INDIANA DEPARTMENT OF TRANSPORTATION

STANDARDS COMMITTEE MEETING AGENDA

RE: Agenda for the October 19, 2006 Standards Committee Meeting

REVISIONS TO 2006 STANDARD SPECIFICATIONS

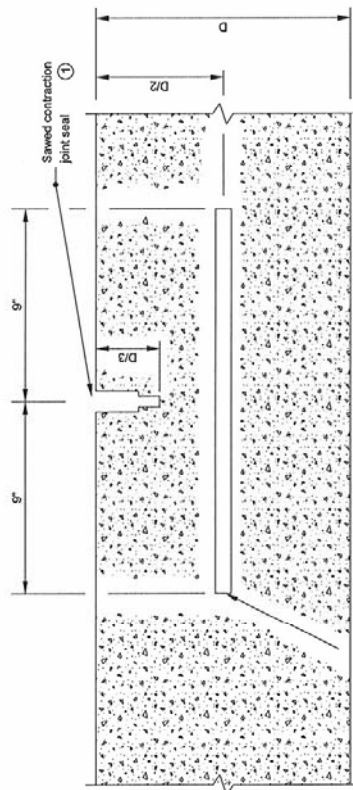
Item No. 16-4
Mr. Heustis
Date: 10/19/06

REVISION TO STANDARD DRAWING

- ① For Type D-1 contraction joint sealant options, see Standard Drawing E 503-CCPJ-06.

BOX BEAM
TYPE CB 305x914
Figure 63-15A

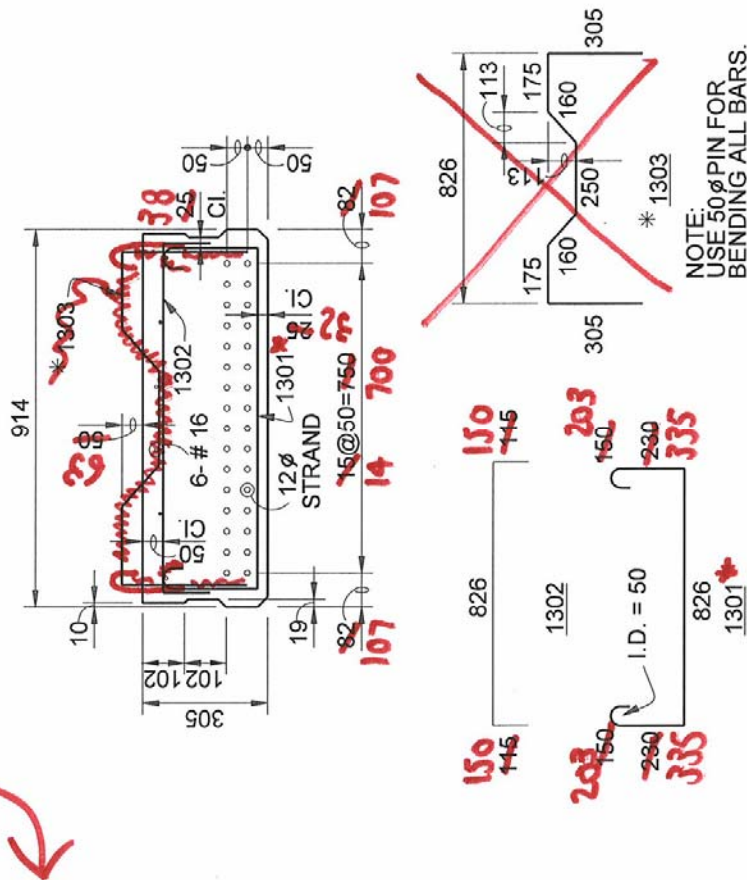
| Wt | = 6.45 kN/m |~~

BEAM PROPERTIES	
AB	= 273,000 mm ²
IB	= 2124 x 10 ⁶ mm ⁴
STB	= 13,885 x 10 ³ mm ³
SBB	= 13,975 x 10 ³ mm ³
YTB	= 153.0 mm
YBB	= 152.0 mm
Wt	= 6.43 kN/m

BOX BEAM
TYPE CB 305x1220
Figure 63-15G

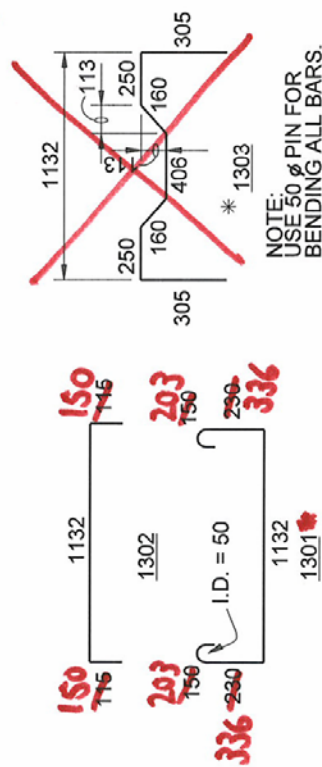
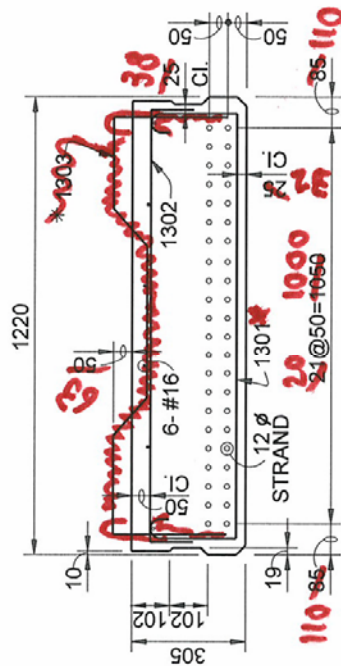
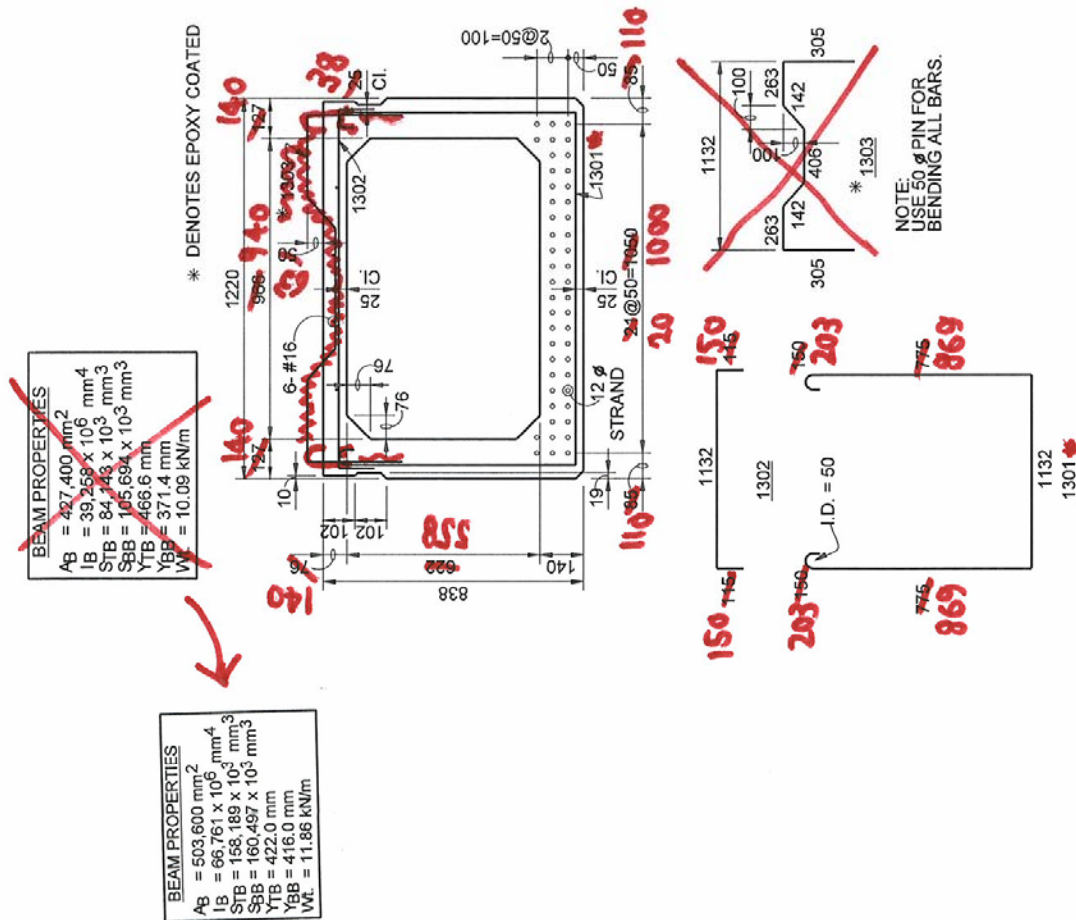
| Wt. | = 8.65 kN/m |~~

BEAM PROPERTIES	
AB	= 366,300 mm ²
IB	= 2,848 x 10 ⁶ mm ⁴
STB	= 18,630 x 10 ³ mm ³
SBB	= 18,719 x 10 ³ mm ³
YTB	= 152.9 mm
YBB	= 152.1 mm
Wt.	= 8.63 kN/m

Figure 67-1 C (2)

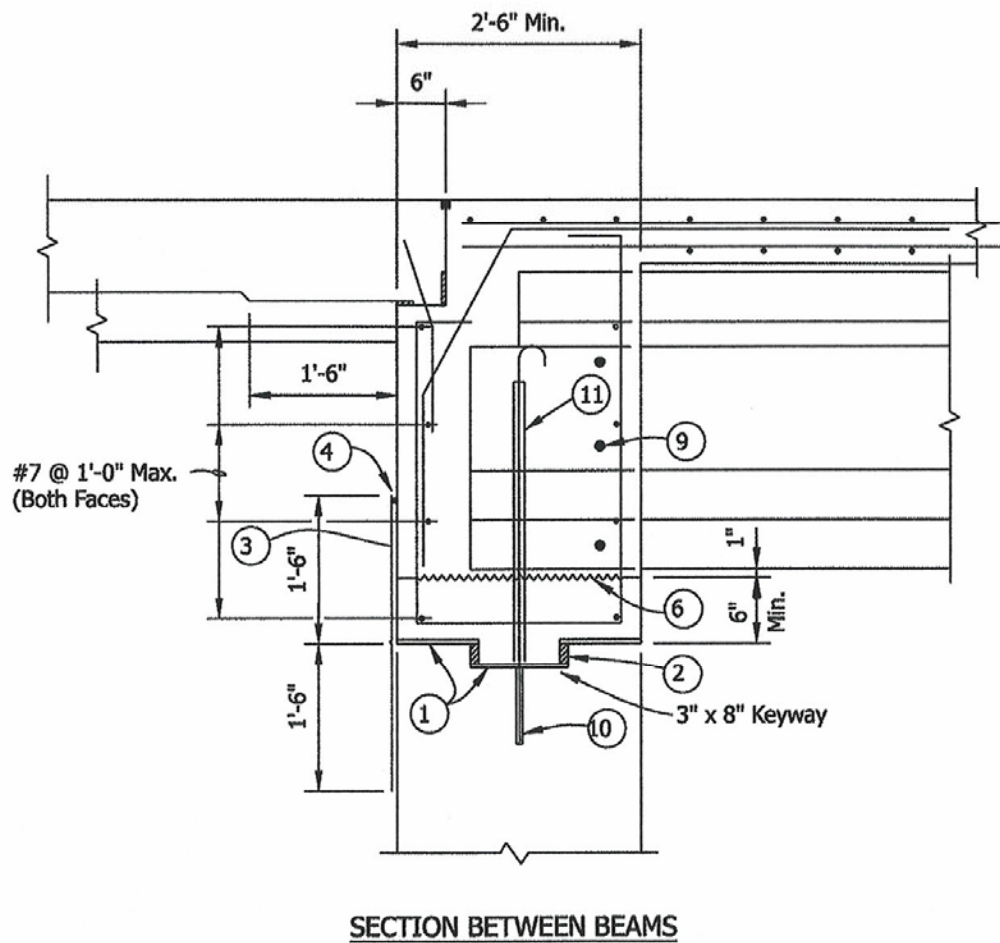
Indiana Design Manual Figure 67-1C(1) shows details for Method 1, and Figure 67-1C(2) shows details for Method 2. Both figures are attached hereto. All applicable information shown in the figures should be shown on the plans.

SUGGESTED SEMI-INTERGRAL END BENT DETAILS
 (Beams Attached to Concrete Cap, Method B)

Figure 67-1 C (1)
(Continued)

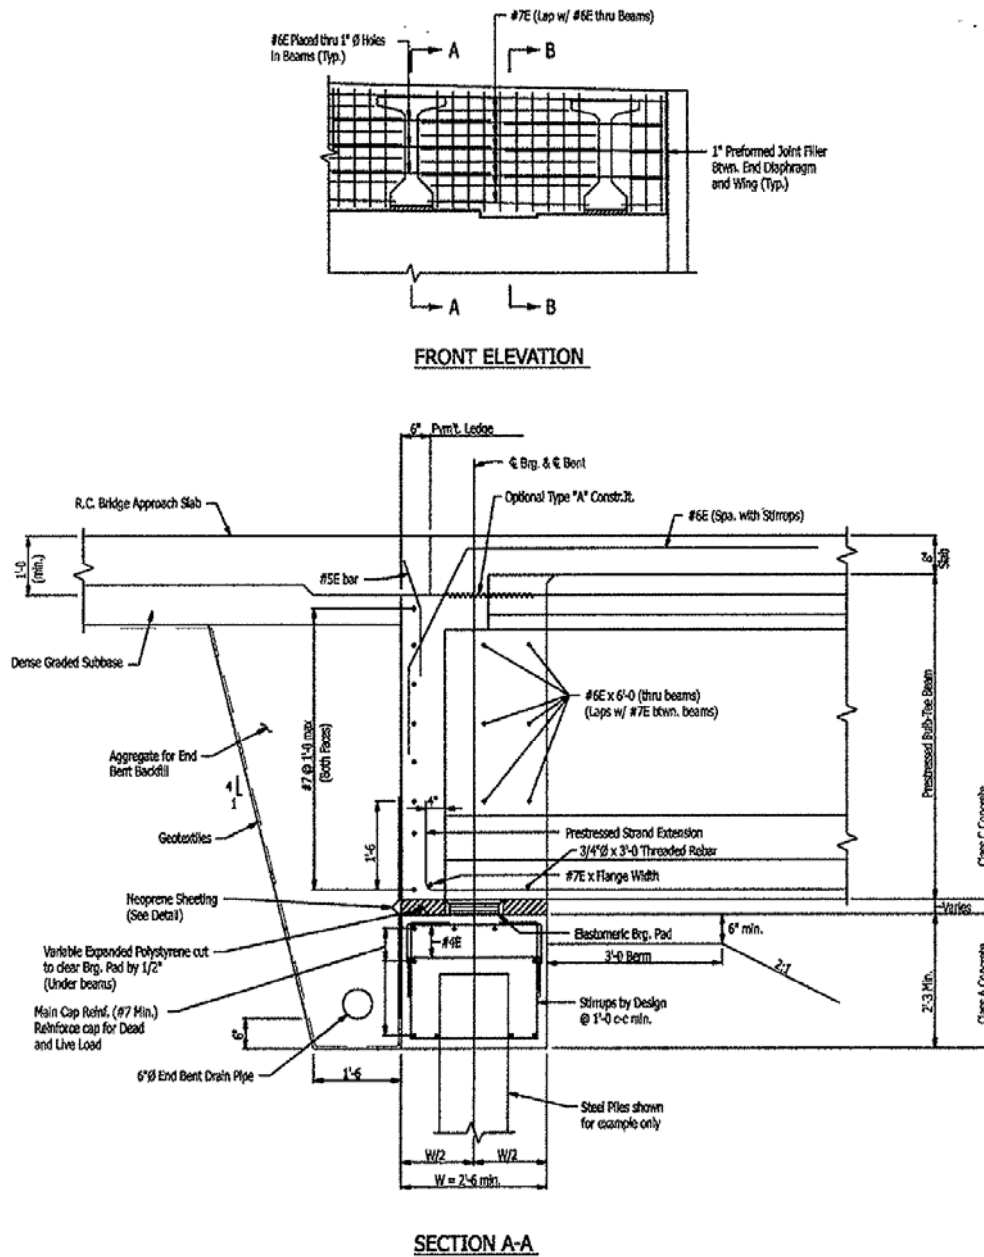
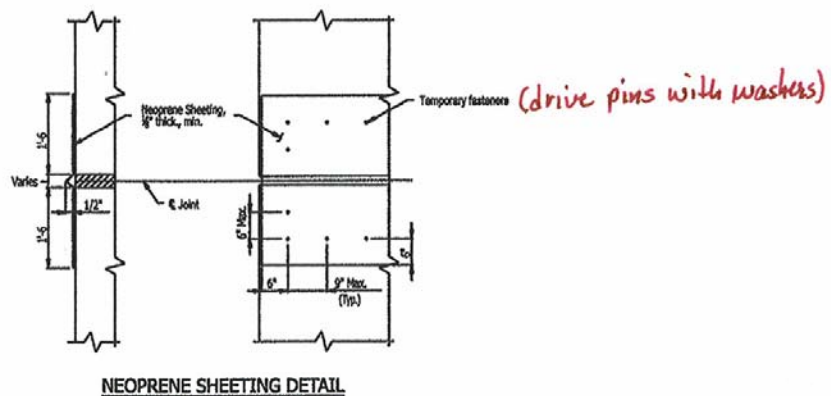
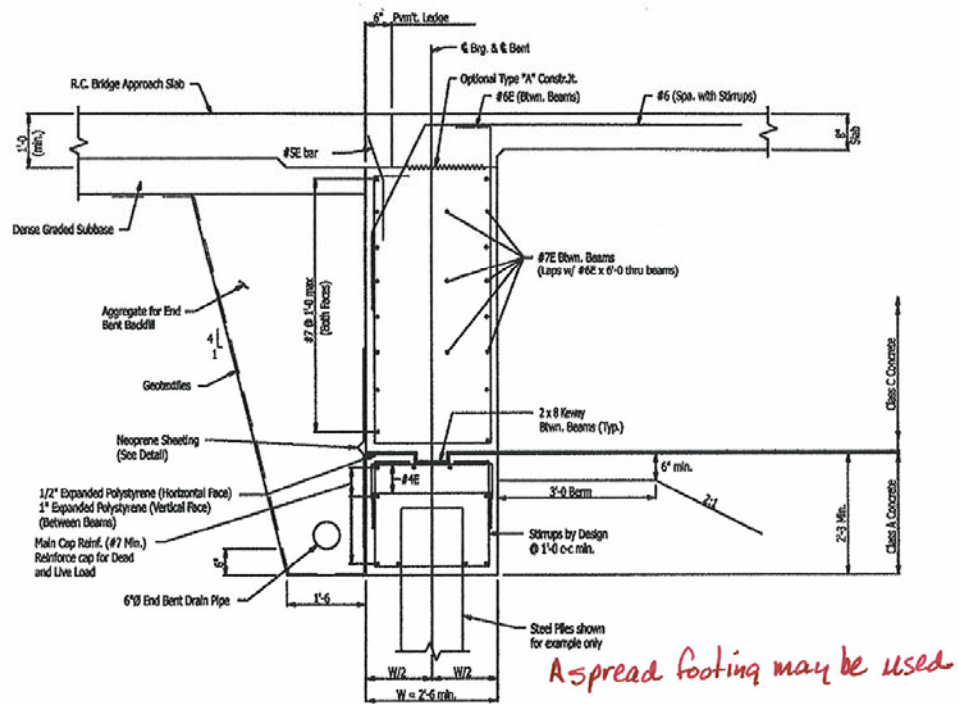
② → **SUGGESTED SEMI-INTERGRAL END BENT DETAILS**
(Beams Attached to Concrete Cap, Method ~~B~~)

② Used only if uplift is expected, or bridge is in Seismic Zone 2.

SUGGESTED SEMI-INTERGRAL END BENT DETAILS (Beams Attached to Piling Method A)

INDIANA DEPARTMENT OF TRANSPORTATION	
CHANNELIZING DEVICES	
SEPTEMBER 2005	
STANDARD DRAWING NO. E 801-TCDV-01	
DESIGNED BY L. J. Anderson DATE 9/05/05	CHECKED BY K. J. Anderson DATE 9/05/05
DRAWN BY L. J. Anderson DATE 9/05/05	CHECKED BY K. J. Anderson DATE 9/05/05

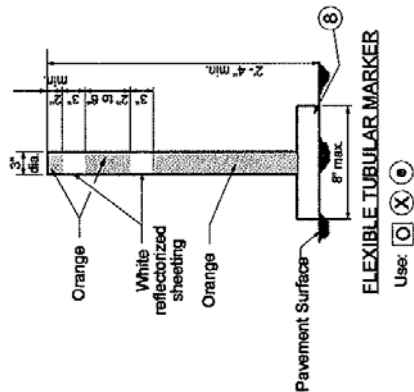
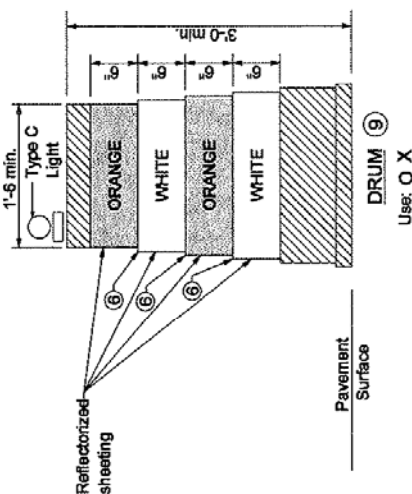
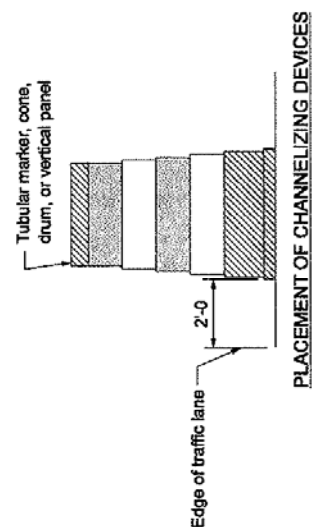
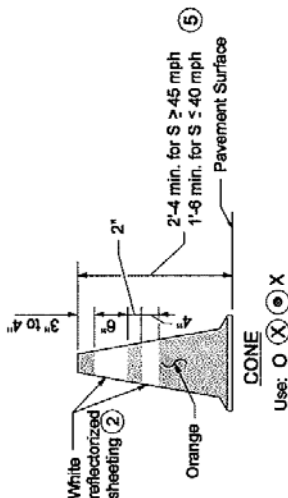
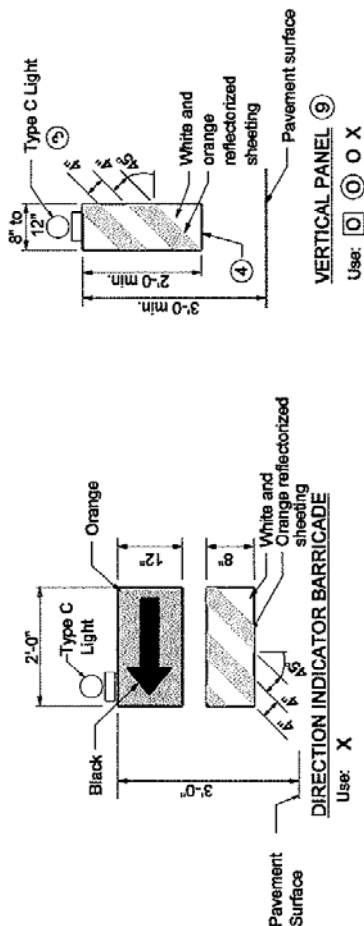
REVISION TO STANDARD DRAWING
801-TCDV-01, Channelizing Devices

My brain is convinced that I submitted this standard drawing change months ago (mid June), but I can find absolutely nothing in my records to back it up.

If this was never done, can you please submit to the Standards Committee?
